2ND STREET APARTMENTS

501 2ND STREET NE, PUYALLUP, WA 98372

PERMIT REVIEW SET

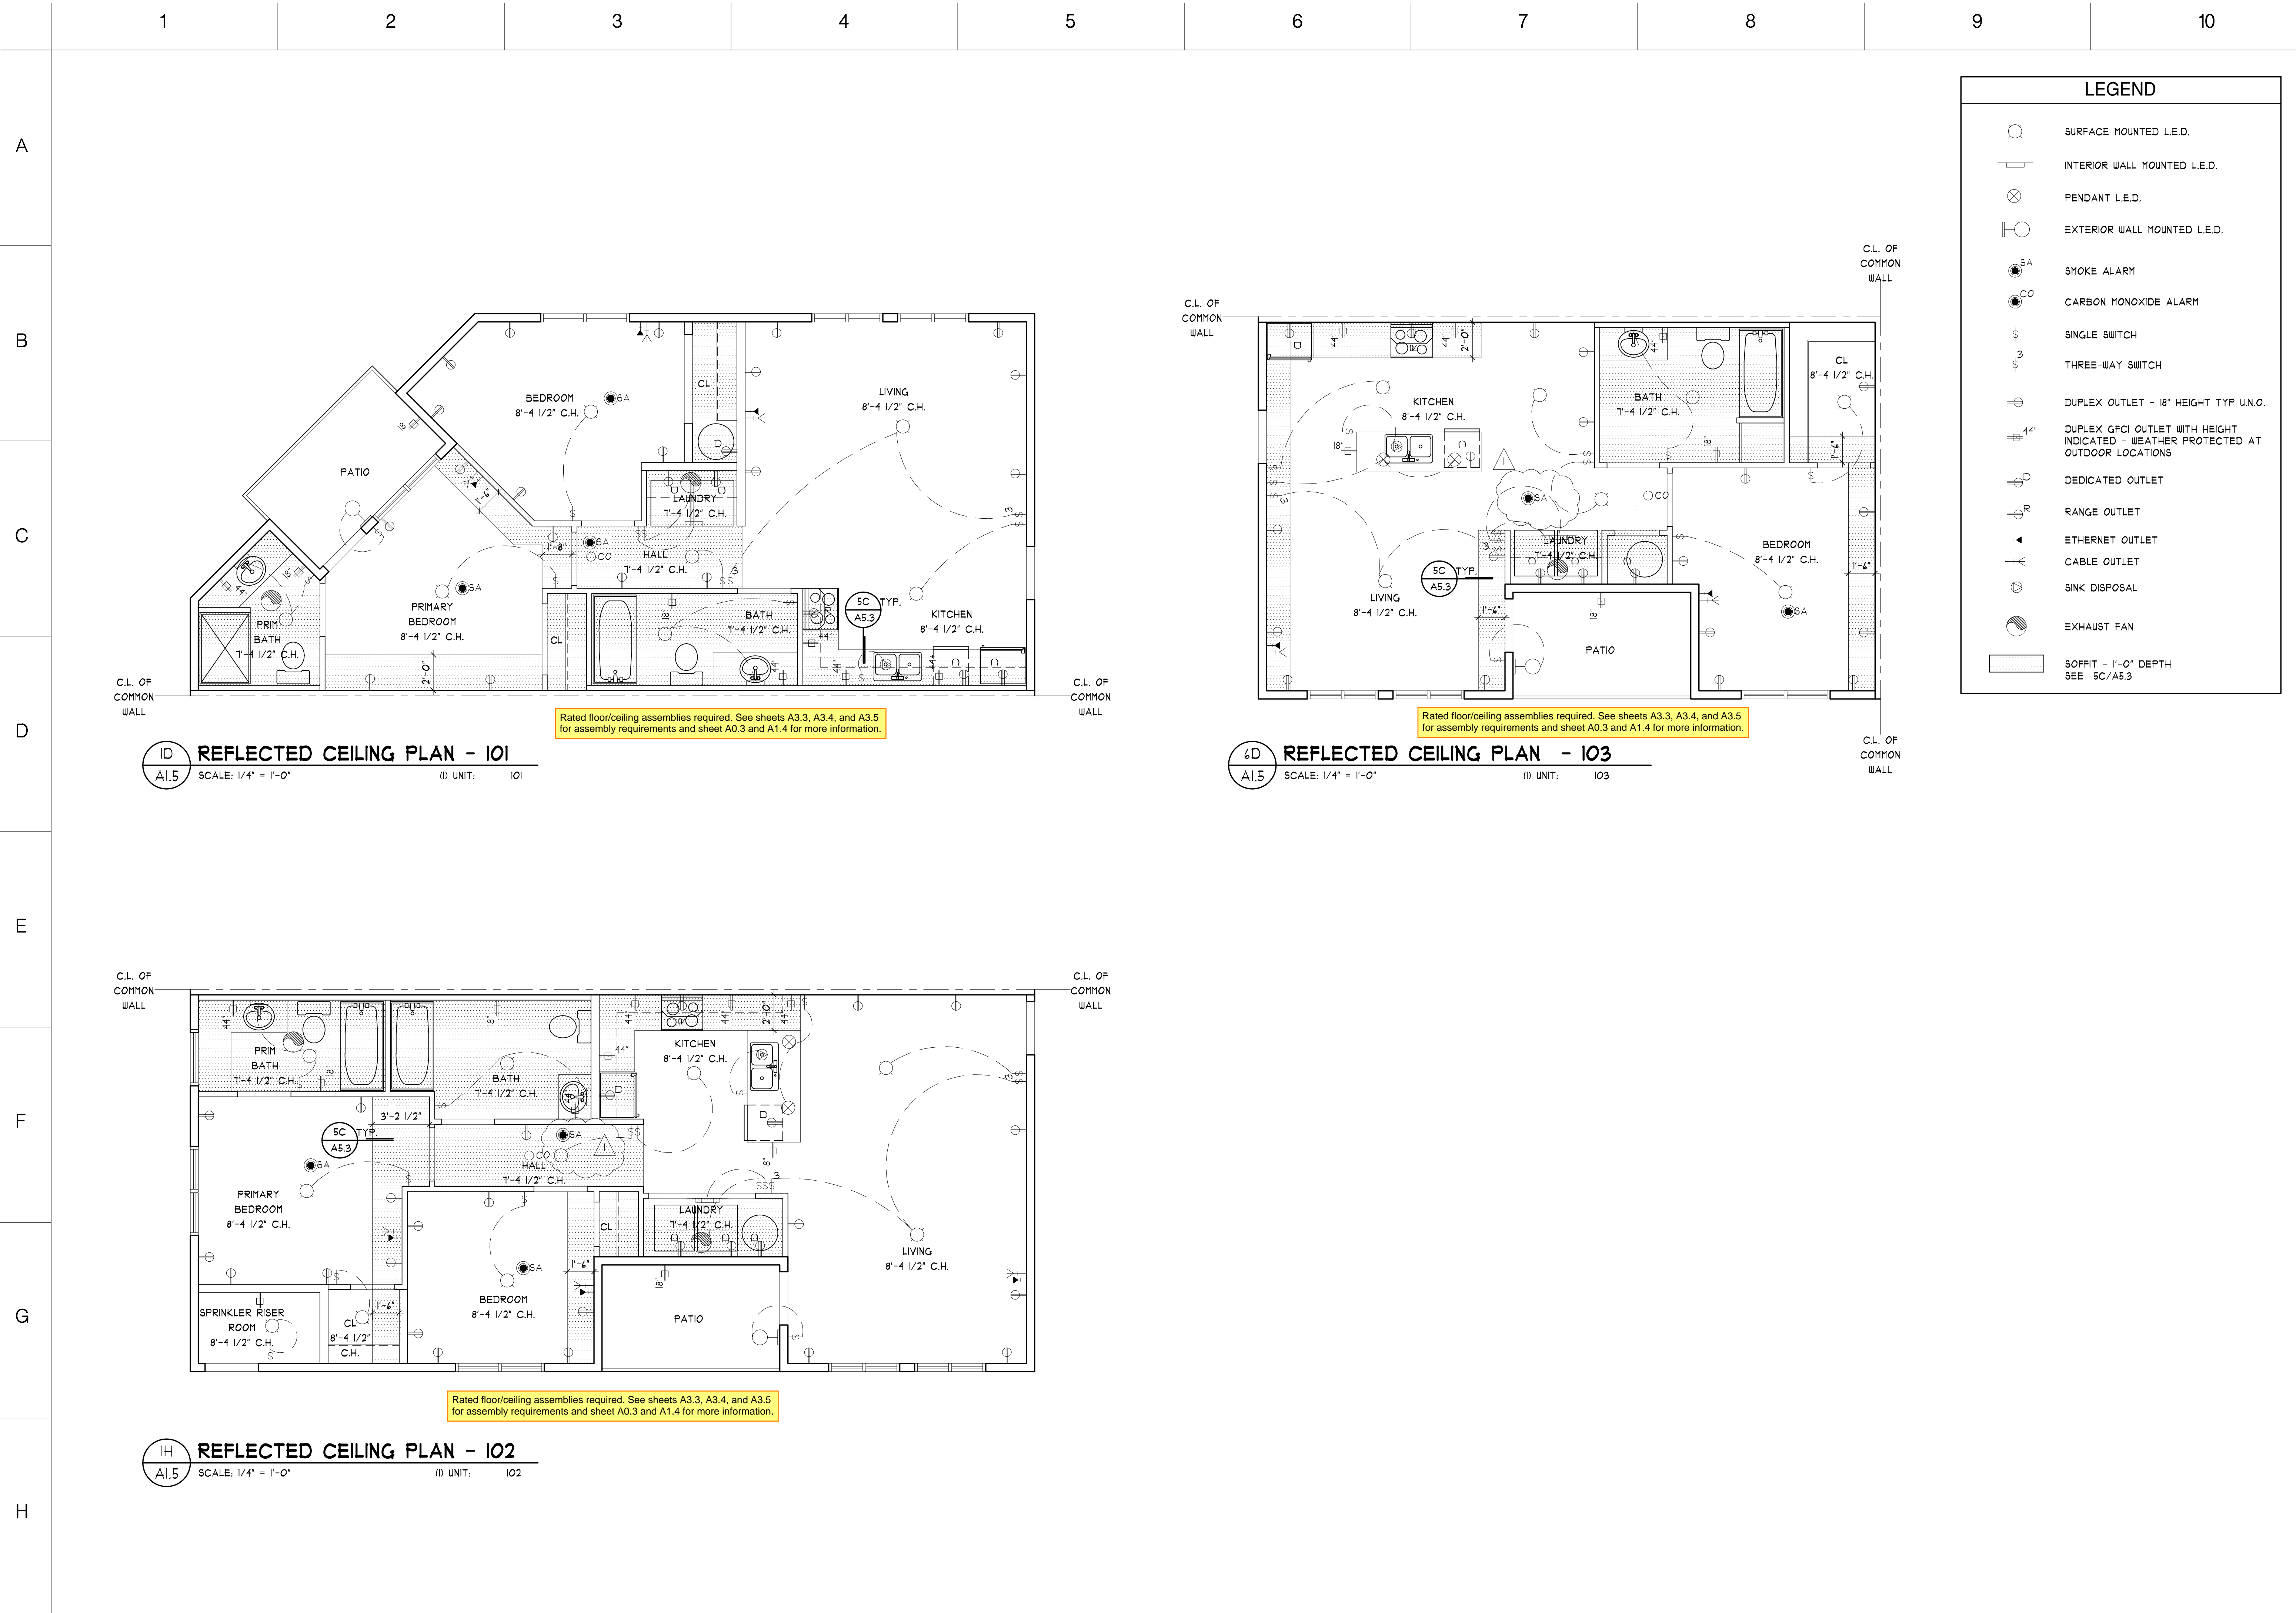
Note: If attic spaces are used to store combustible materials, the attic must be protected with either an approved automatic sprinkler system or with 1-hour fire-resistance rated construction, typical.

UNIT 101 - TYPE A ACCESSIBILITY PLAN

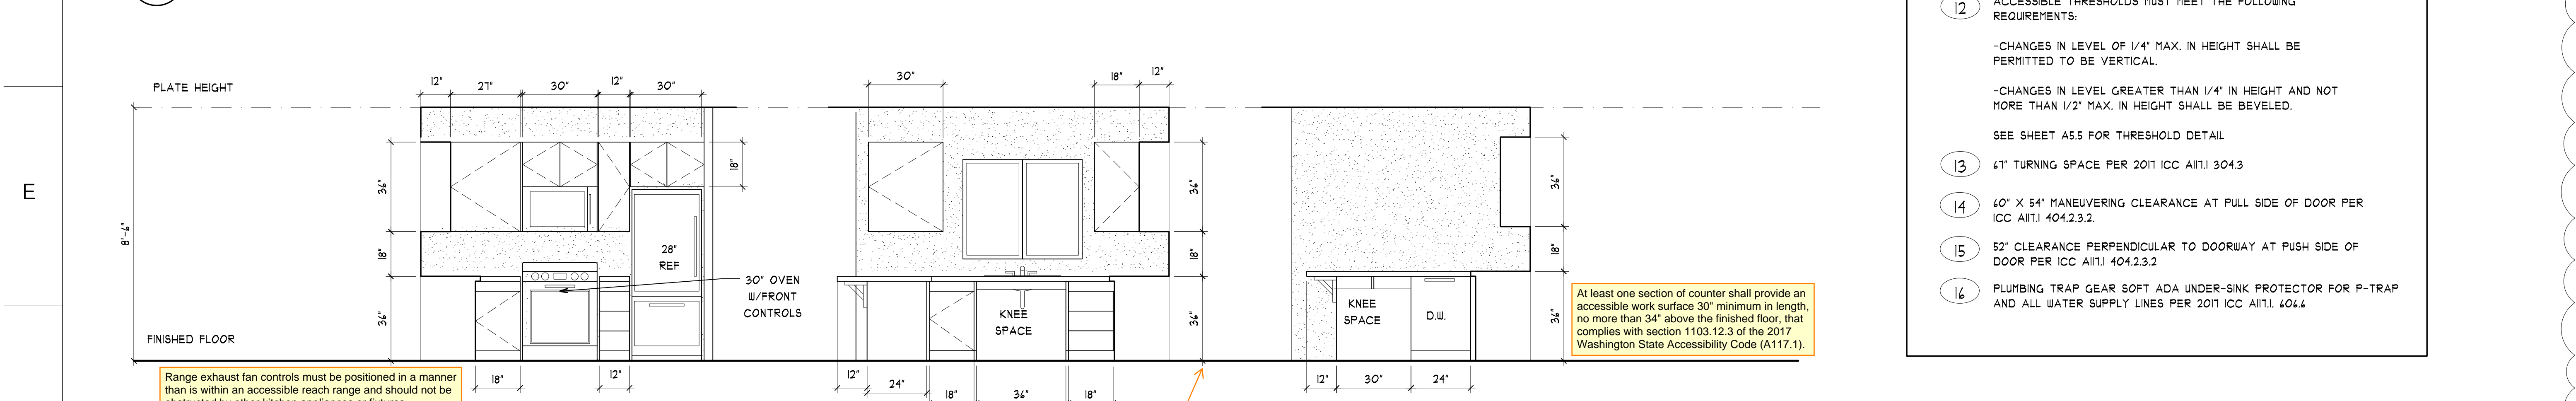
[ICC A117.1-2017 section 1103.12.1.2]  
U-Shaped Kitchens  
In kitchens with counters, appliances, or cabinets on three contiguous sides, clearance between all opposing base cabinets, countertops, appliances, or walls within kitchen work areas shall be 60 inches (1525 mm) minimum.

Not applicable at Type-A units. Minimum clearance required for Bathtubs in Type-A units is 30"xLength of the Bathtub (and seat if the seat is permanent).

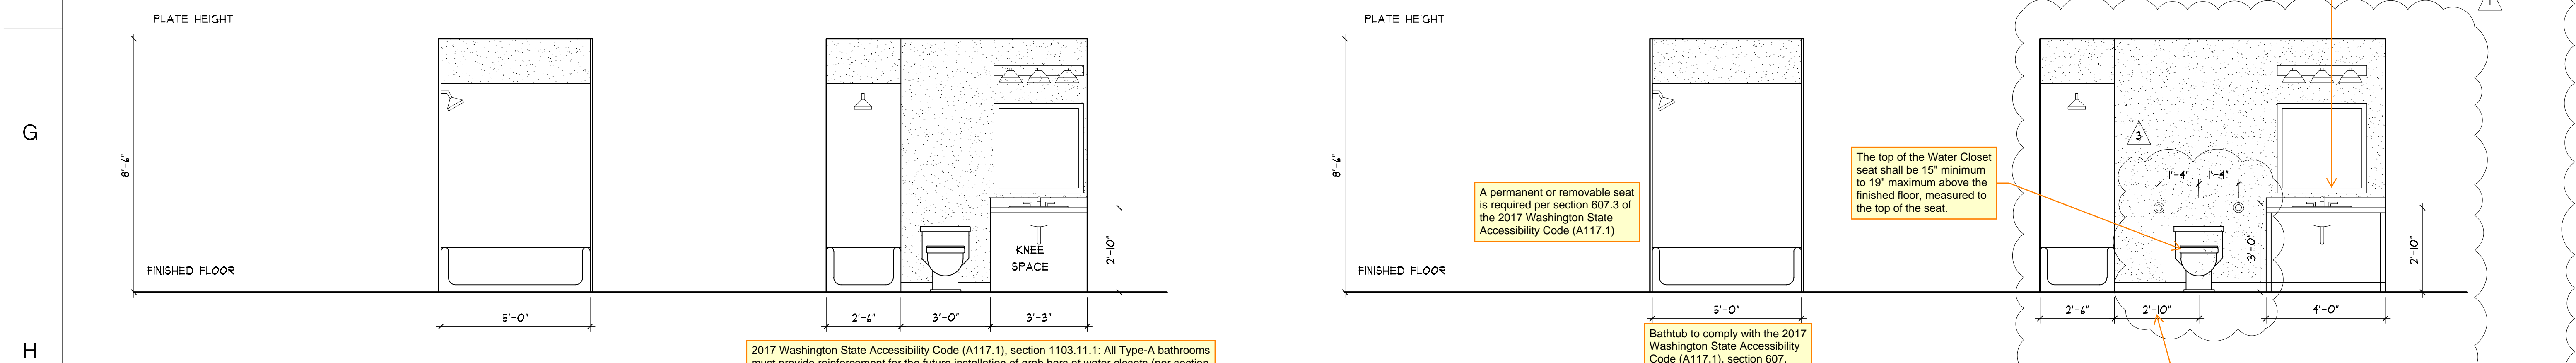
Range exhaust fan controls must be positioned in a manner than is within an accessible reach range and should not be obstructed by other kitchen appliances or fixtures.

At least one section of counter shall provide an accessible work surface 30" minimum in length, no more than 34" above the finished floor, that complies with section 1103.12.3 of the 2017 Washington State Accessibility Code (A117.1).

2017 Washington State Accessibility Code (A117.1), section 1103.11.1: All Type-A bathrooms must provide reinforcement for the future installation of grab bars at water closets (per section 604.5), grab bars at bathtubs (per section 607.4), and grab bars and shower seats at shower compartments (per section 608) except locations listed under the exception as not required.

STATE OF WASHINGTON

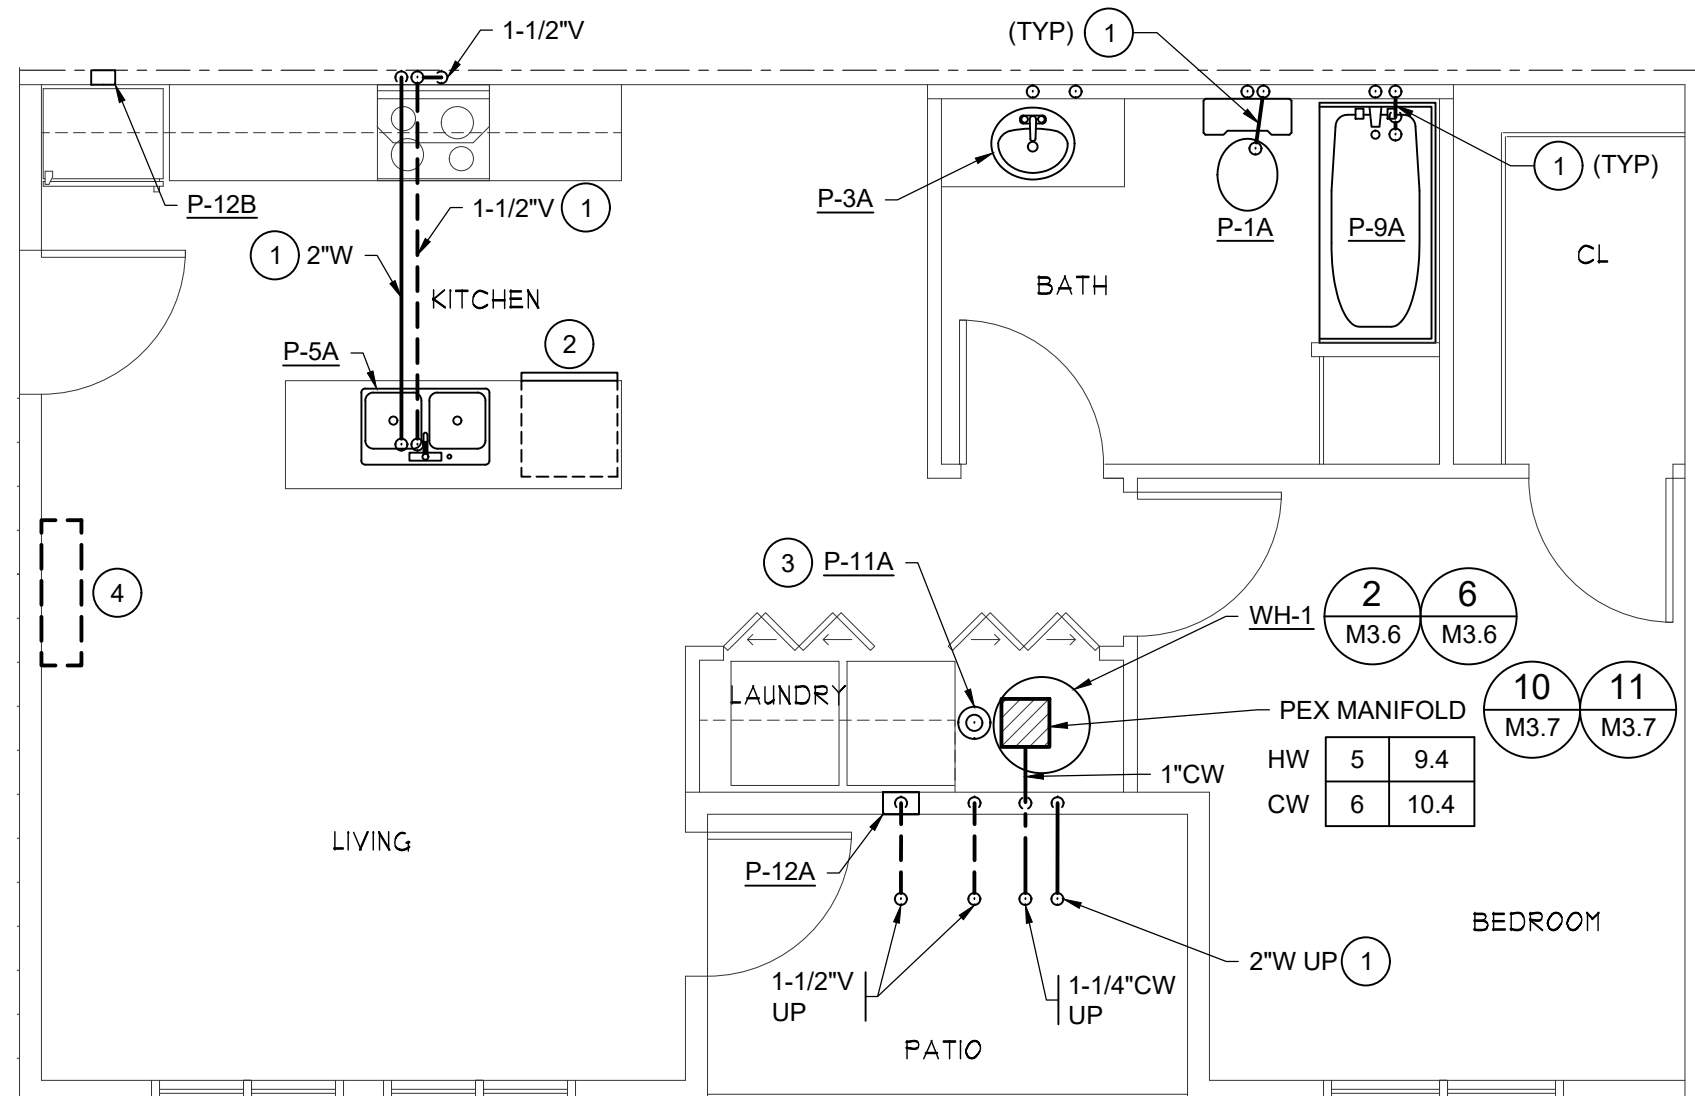
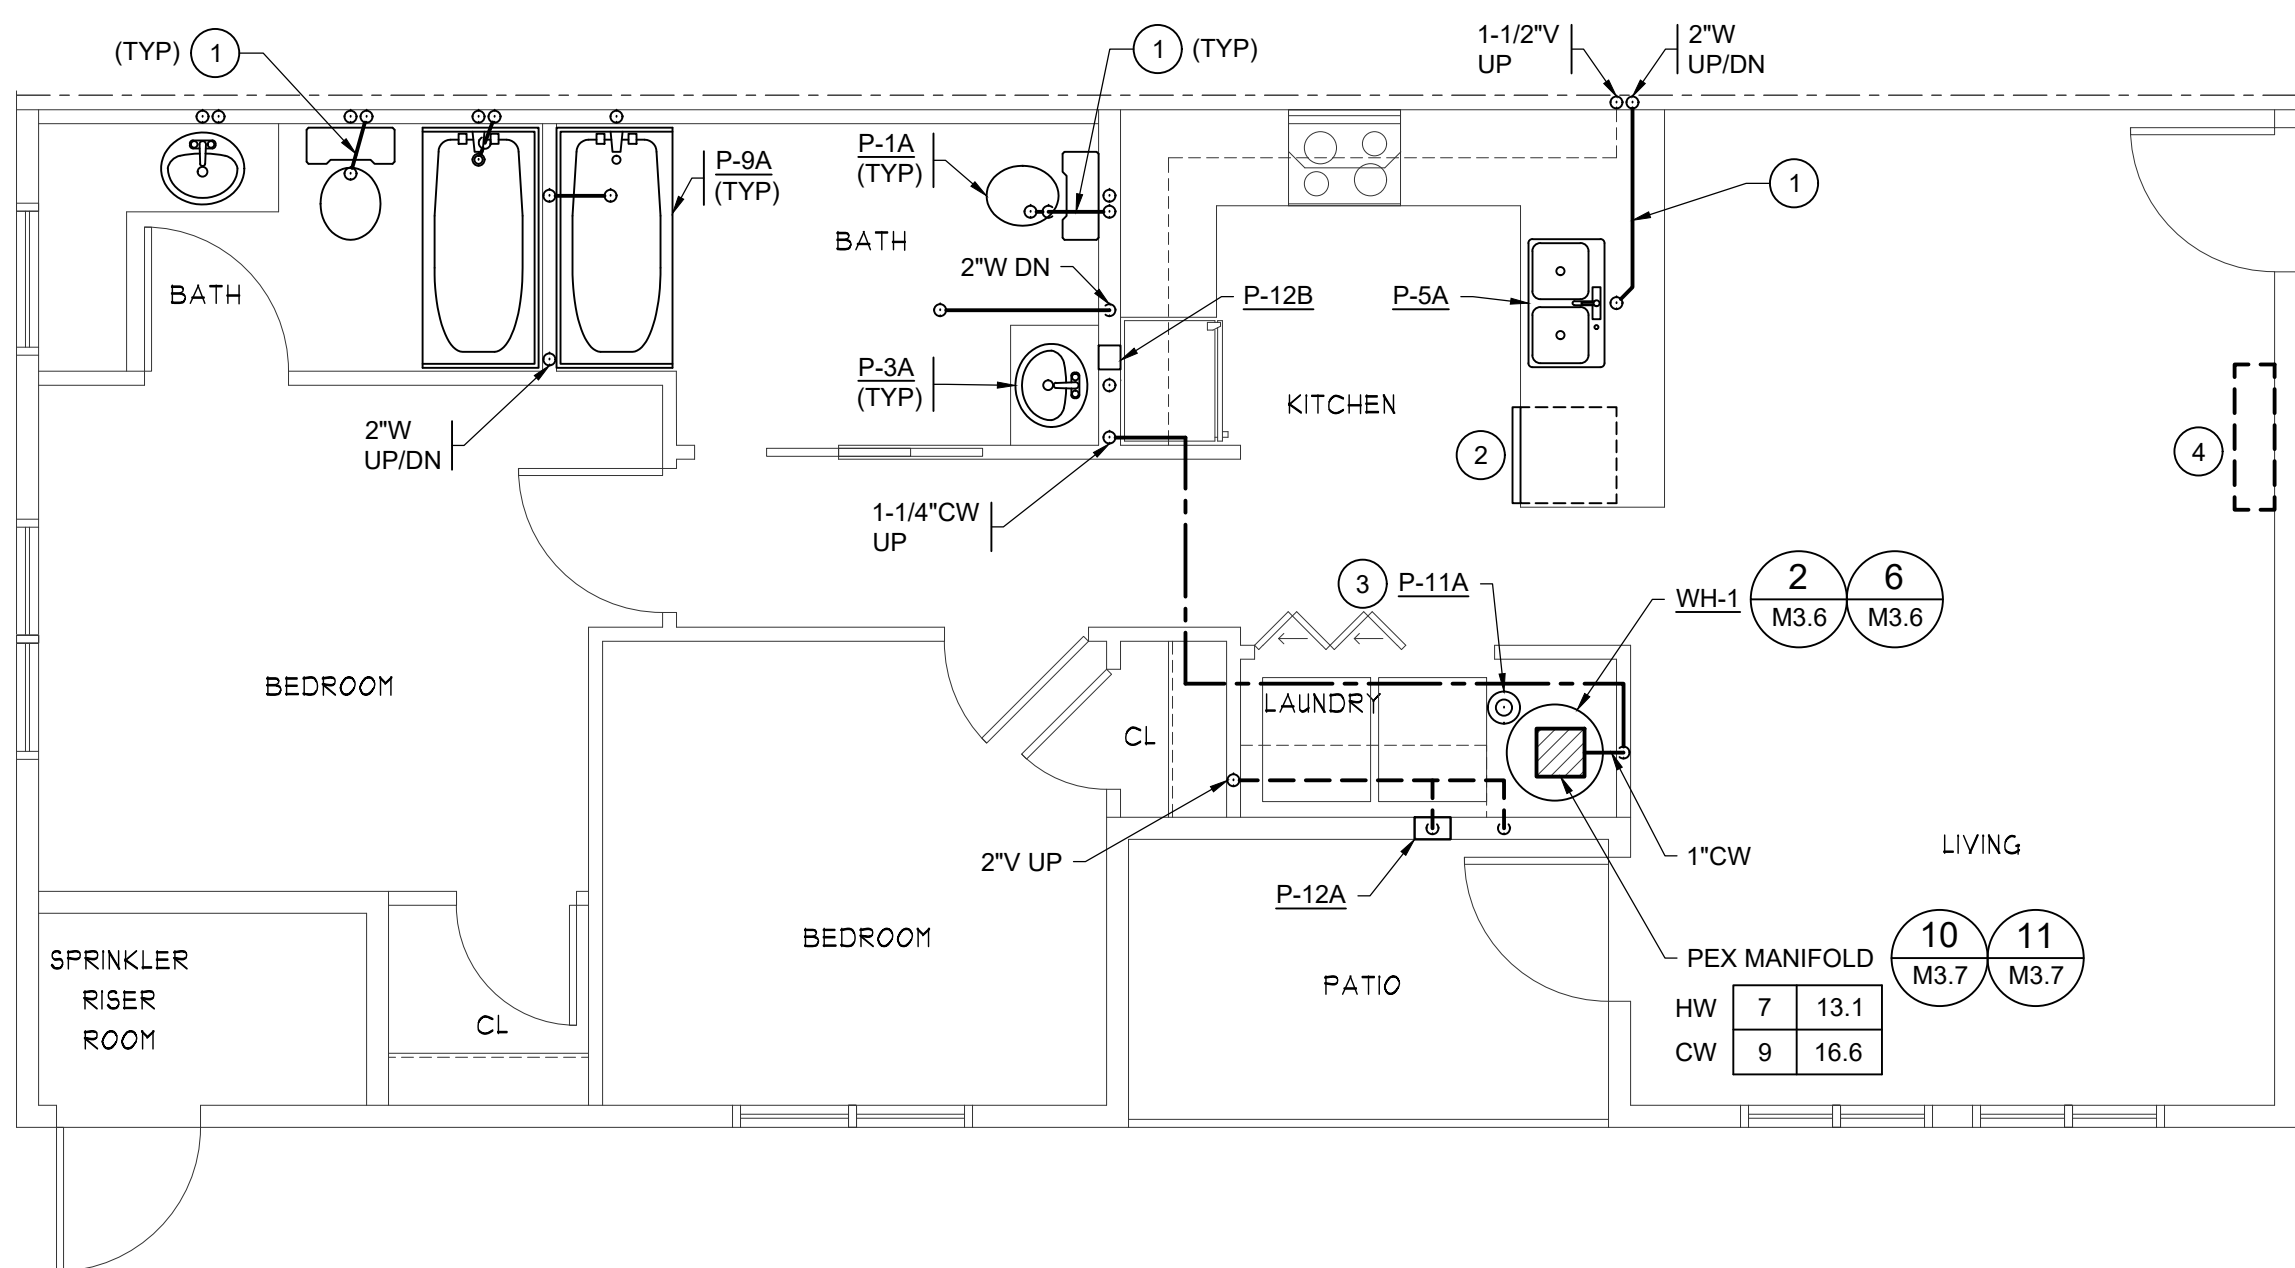
City of Puyallup  
Development & Permitting Services  
ISSUED PERMIT
